PLANS AND DOCUMENTS referred to in the PDA DEVELOPMENT APPROVAL
Approval no: DEV2016/759
Date: 25 January 2017
Queensland Government

AMENDED IN RED
By: Chessa Lao
Date: 10 February 2025
Queensland Government

AMENDED IN RED
By: Essen Joseph
Date: 15-Feb-2022
Queensland Government

nra-co-lab™
© Copyright Noel Robinson Architects Pty Ltd.
KINGSFORD
527 GREGORY TCE
STAGING PLAN
89084C16
SK9100
DATE: 16/01/2017 5:18:11 PM
SCALE: 1 : 200 @A1
SCALE : 1 : 200@ A1

1 Staging Plan
1 : 200

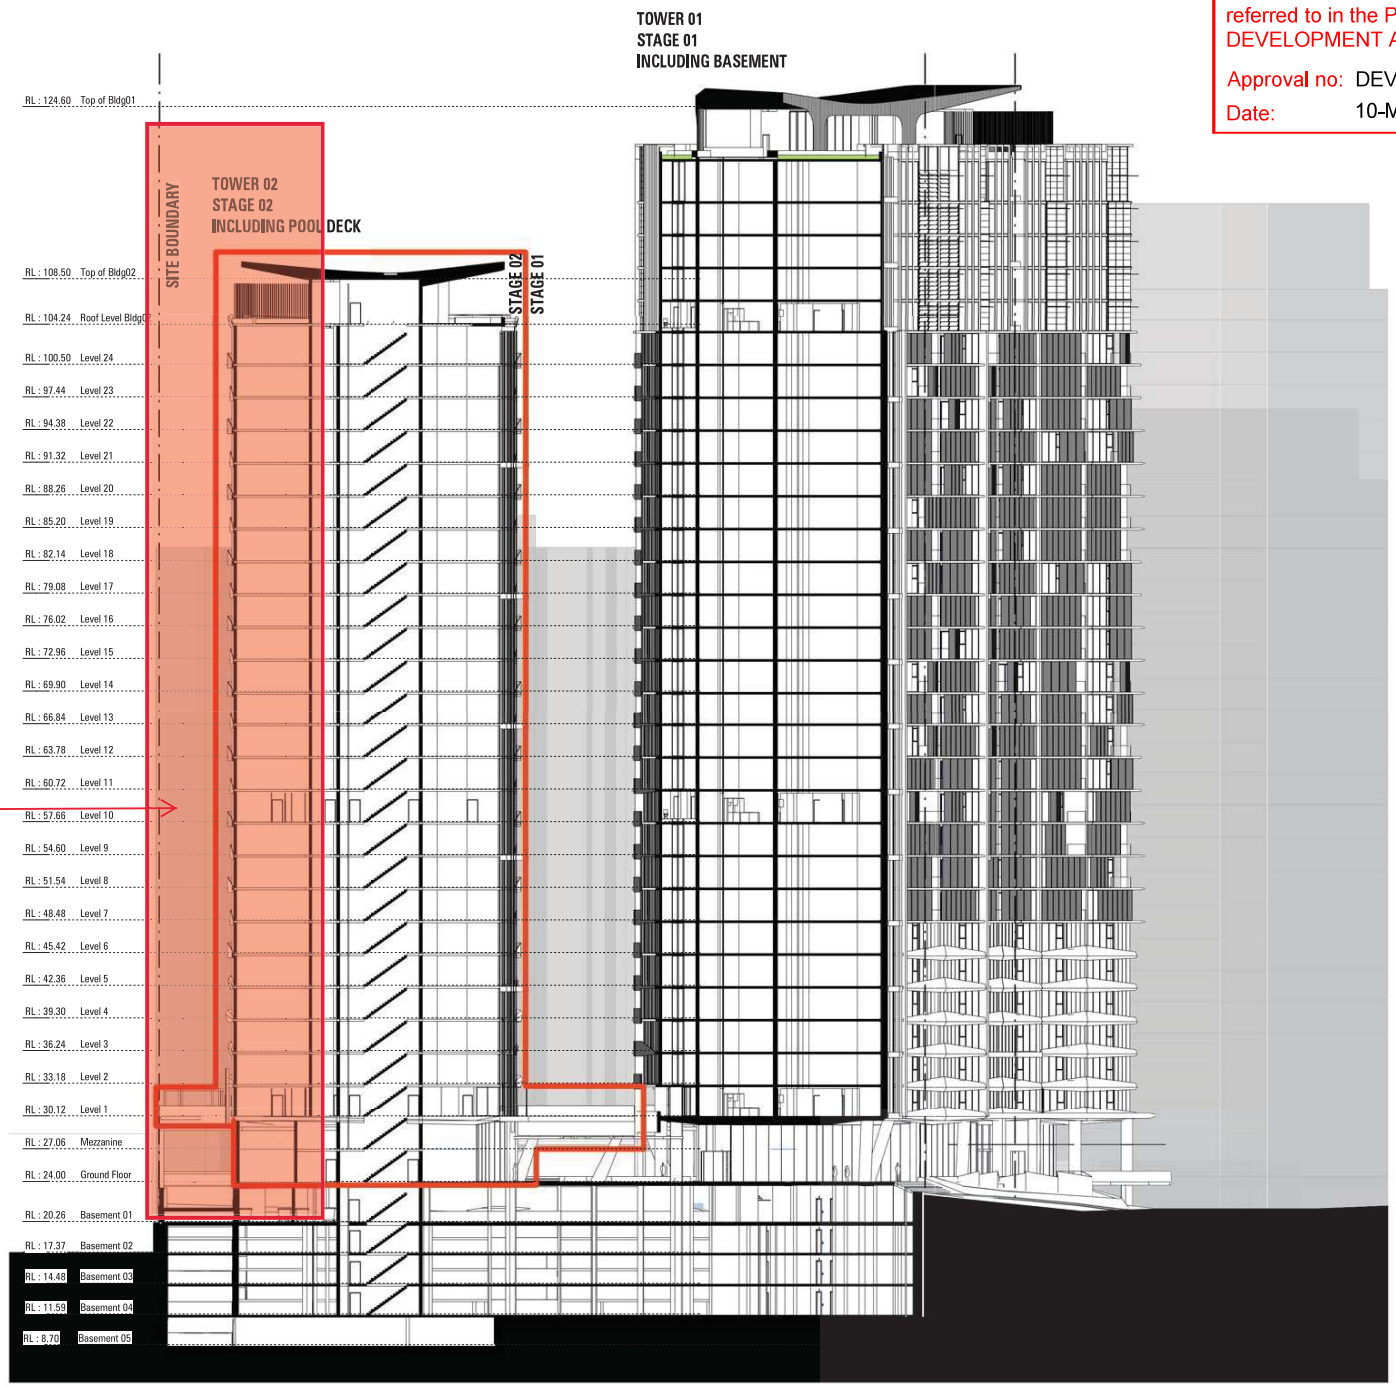
Increase building setback to 9m from boundary. Reconfigure apartments / building design to achieve setback.

Reconfigure outlook of habitable spaces of all apartments on the eastern boundary towards Gregory Tce and the Drill Hall (e.g. through the use of a fin-shaped floor plate, providing solid walls to the north-east, but large windows looking north and south).

Each tower to achieve:
- a maximum tower footprint of 1,200m², and
- a maximum horizontal dimension of 50.0 metres for any part of the building.

Provide an 18.0 metre tower setback between Tower 1 and Tower 2.

1 SECTION BB - TOWER 2 STAGING PLAN
1 : 250

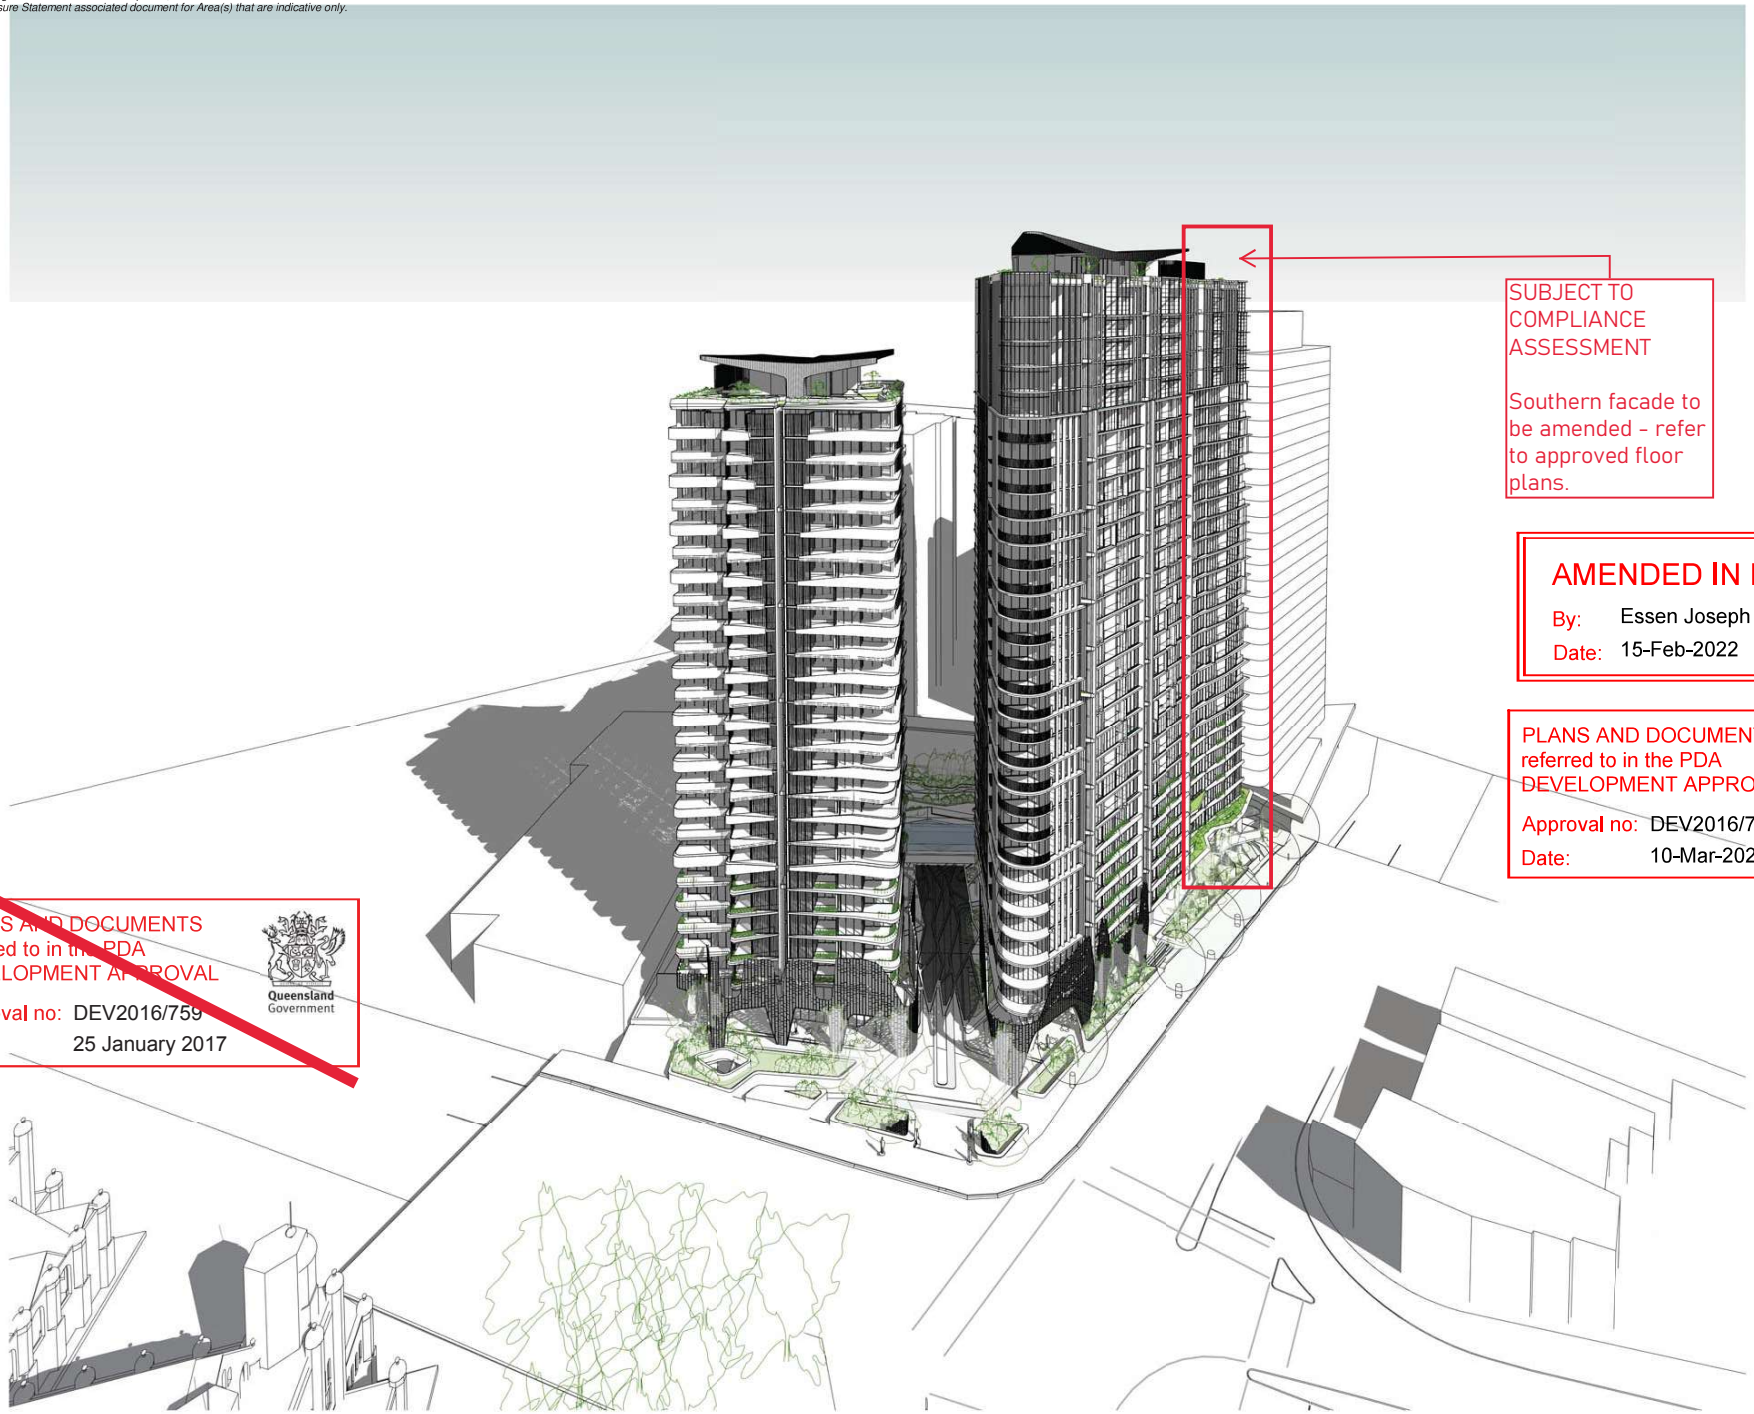
Reconfigure outlook of habitable spaces of all apartments on the eastern boundary towards Gregory Tce and the Drill Hall (e.g. through the use of a fin-shaped floor plate, providing solid walls to the north-east, with large windows looking north and south).

PERSPECTIVE

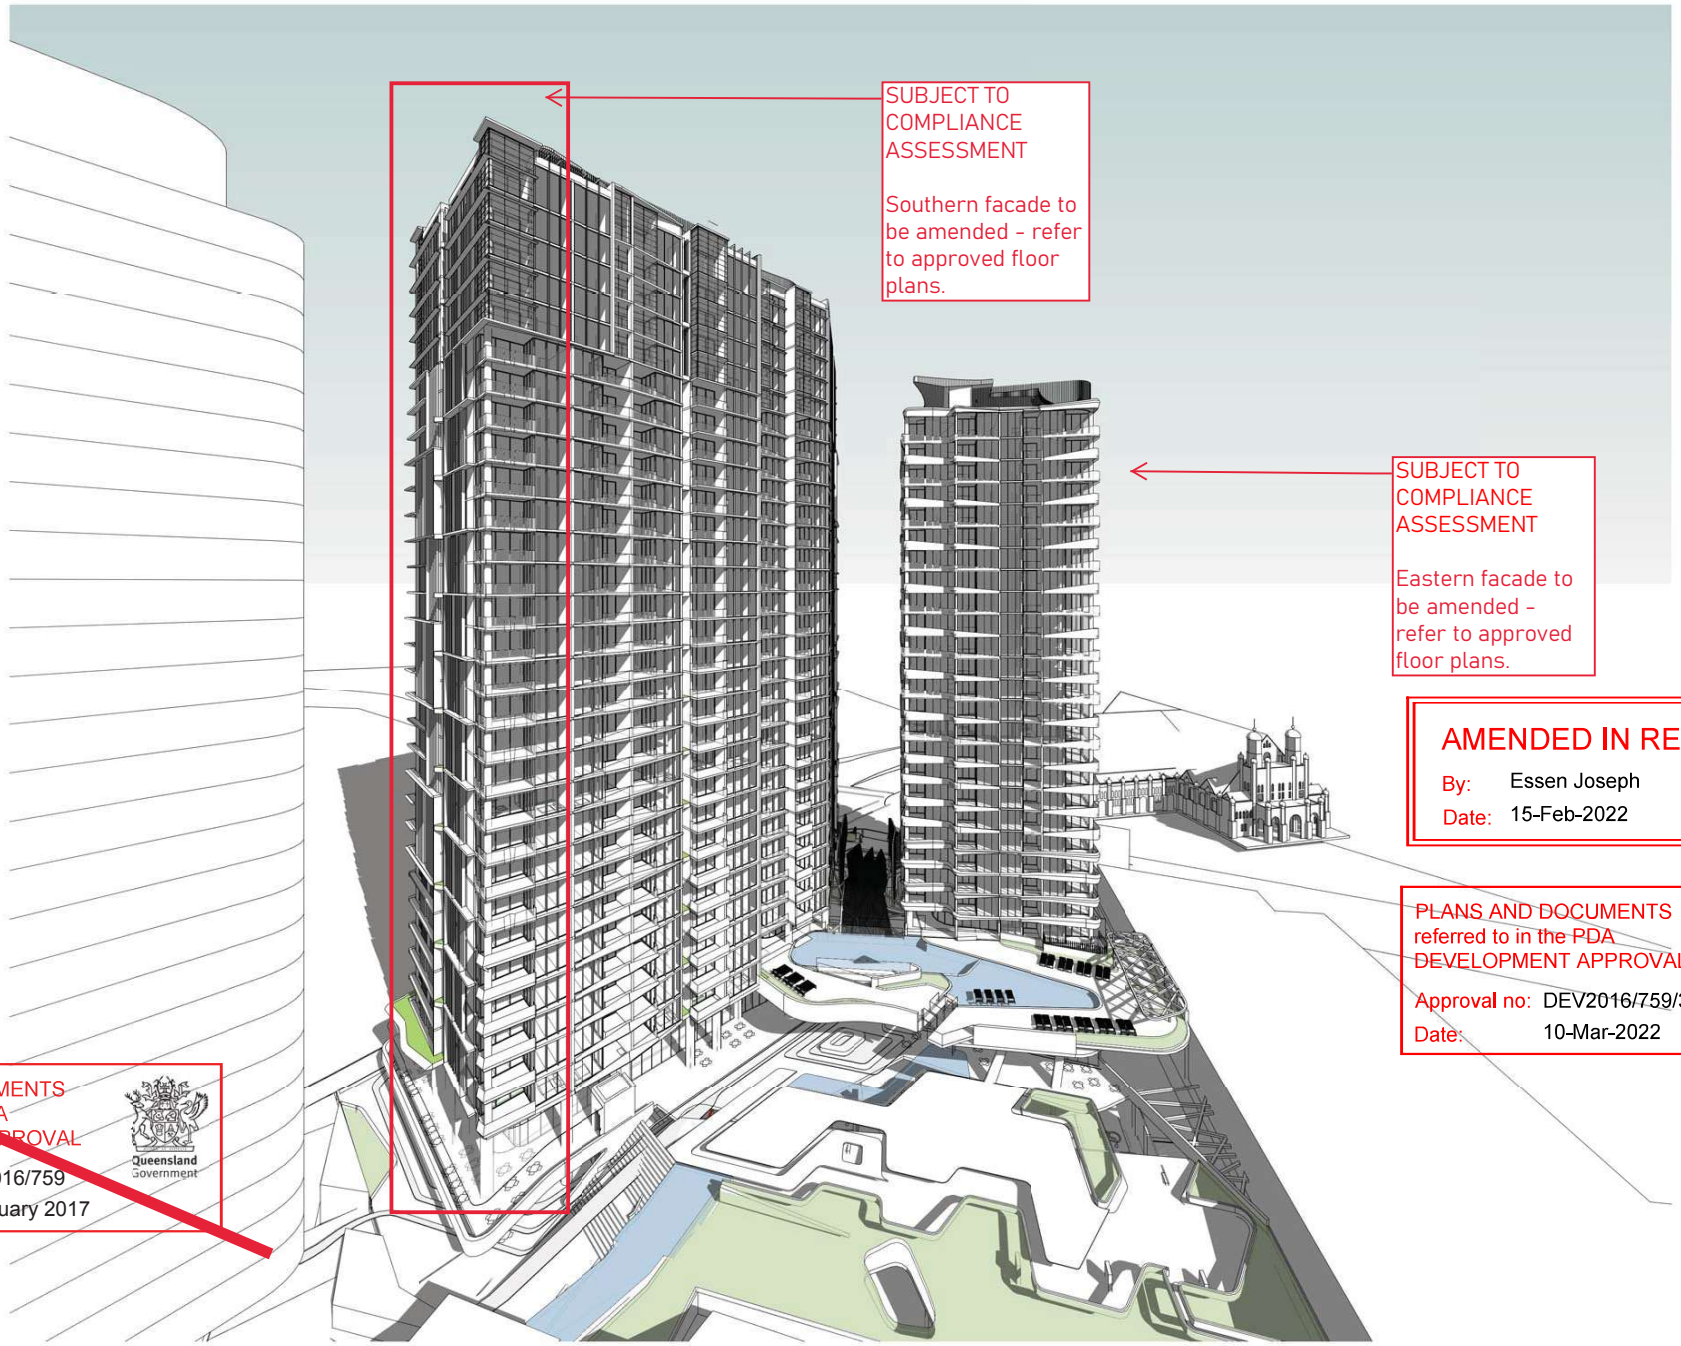
Southern facade to be amended - refer to approved floor plans.

KINGSFORD | 527 GREGORY TCE | ENTRY

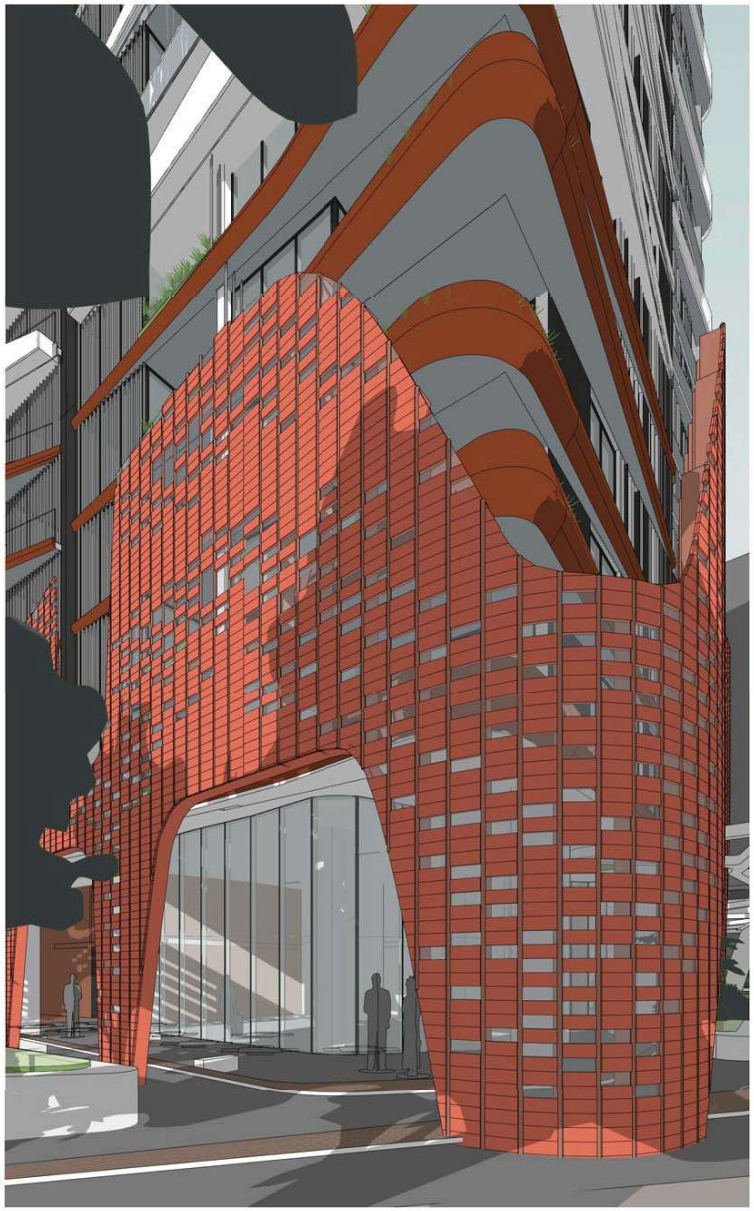
Eastern facade to be amended - refer to approved floor plans.

Basement 01

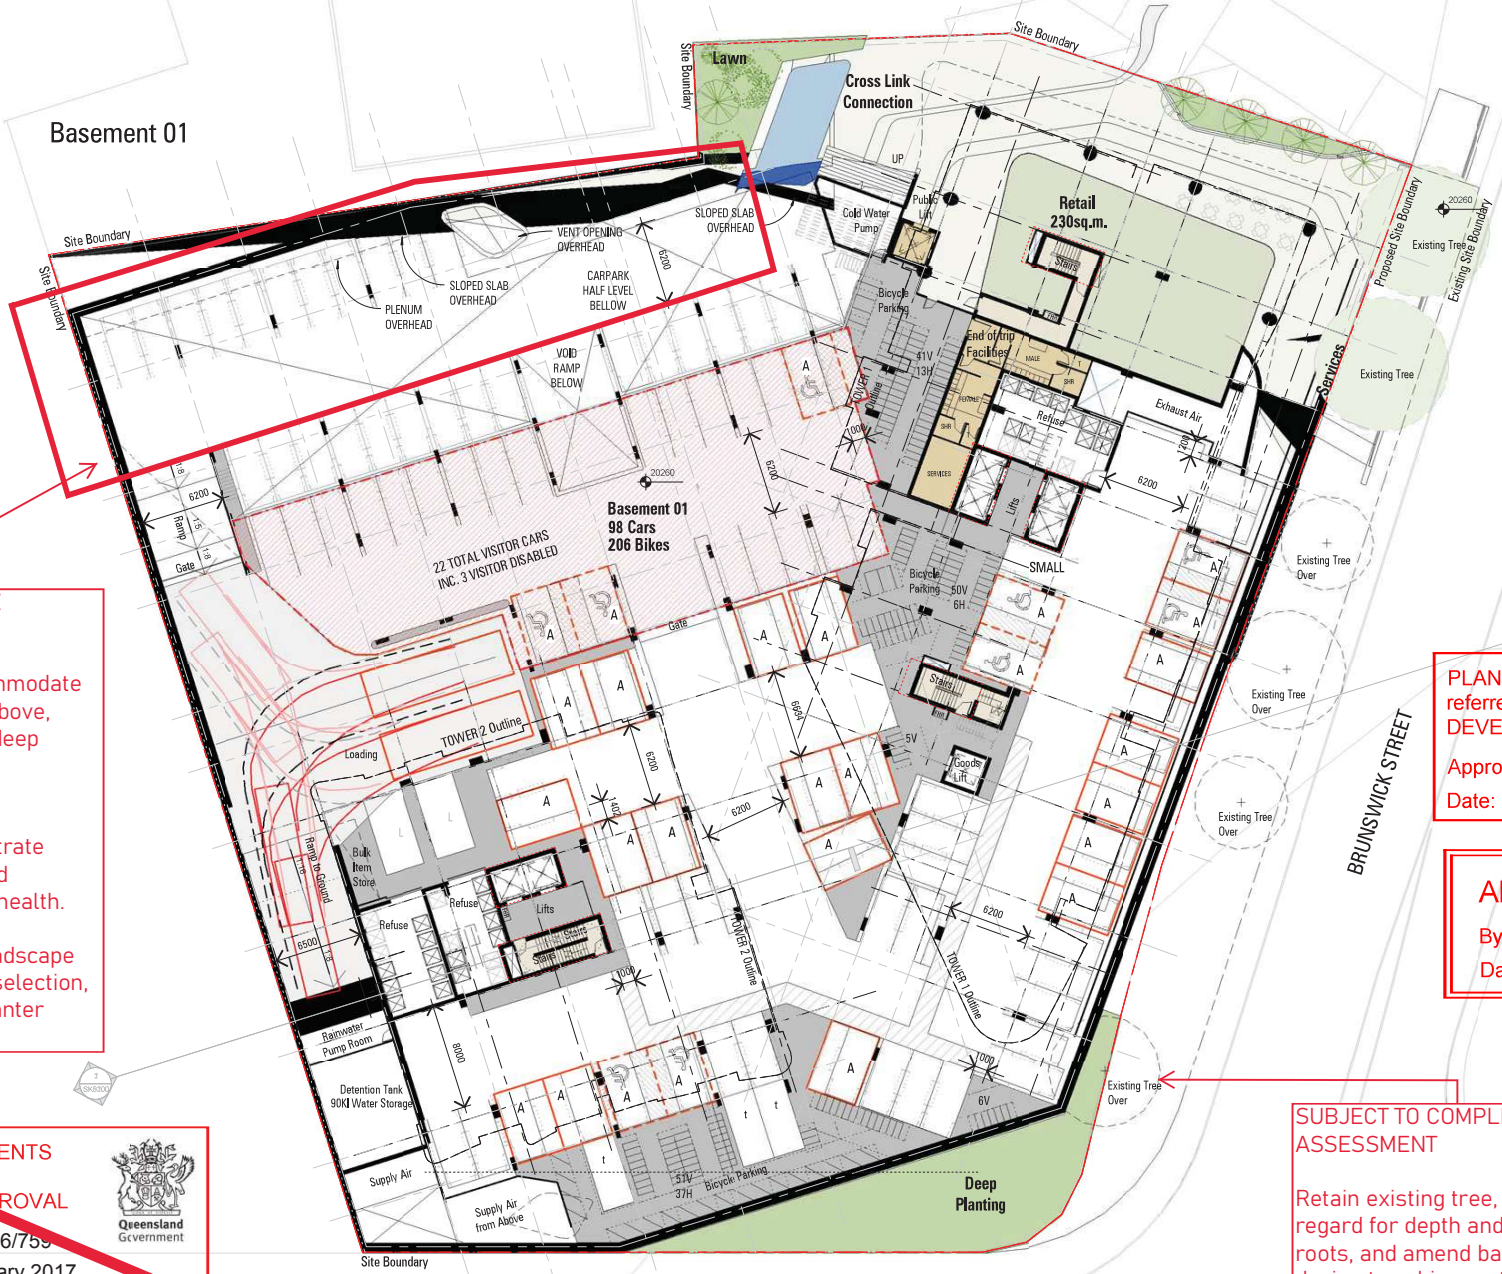
Basement design to accommodate planting of mature trees above, commensurate with BCC deep planting requirements.

See also the approved Landscape Design Intent for species selection, and its implications for planter design.

TOWER 2

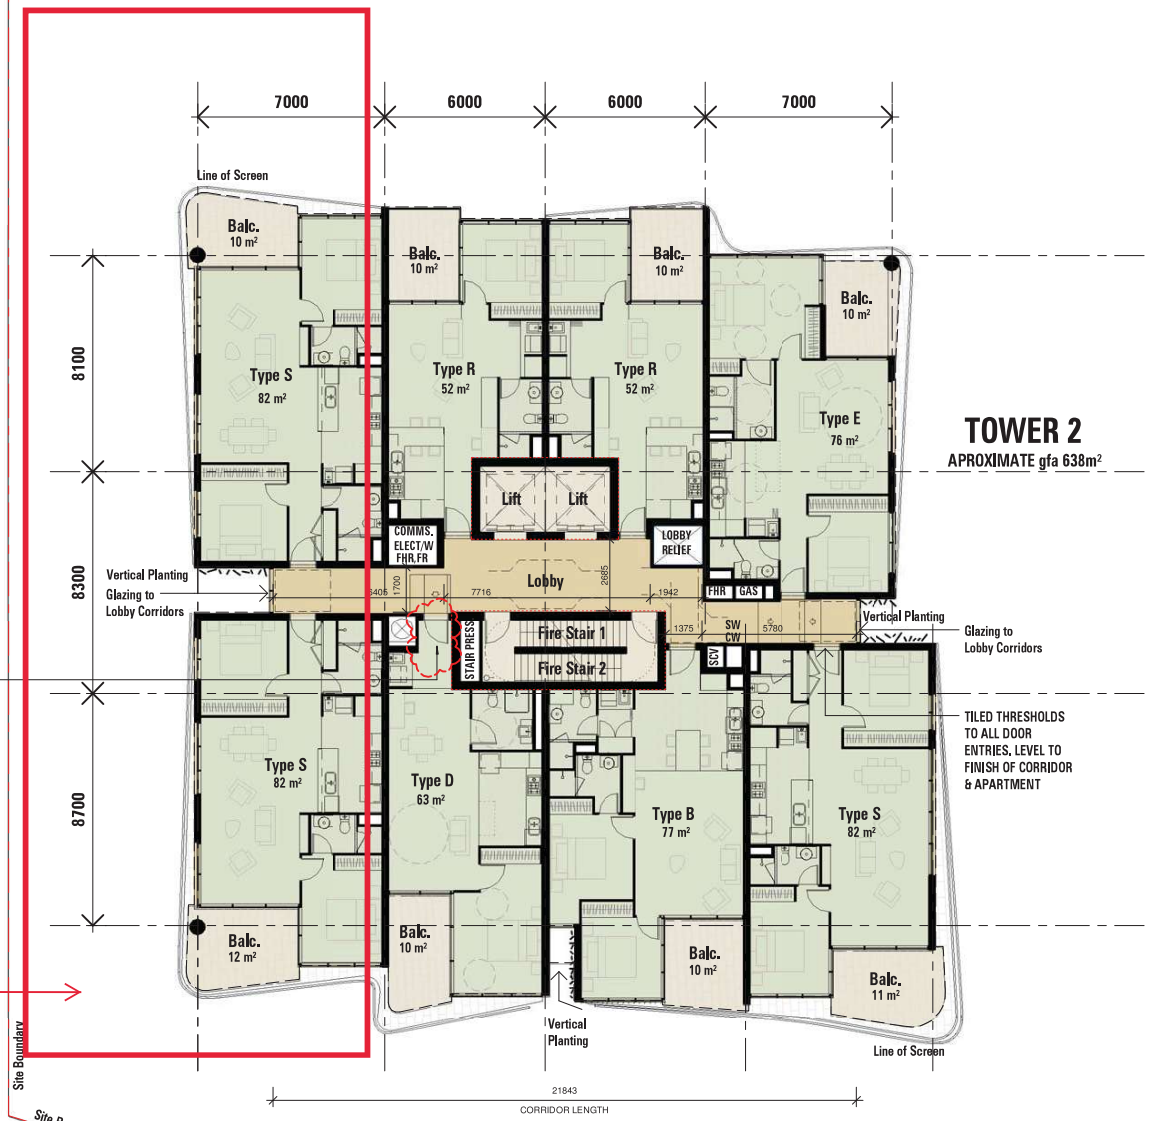
Reconfigure outlook of habitable spaces of all apartments on the eastern boundary towards Gregory Tce and the Drill Hall (e.g. through the use of a fin-shaped floor plate, providing solid walls to the north-east, with large windows looking north and south).
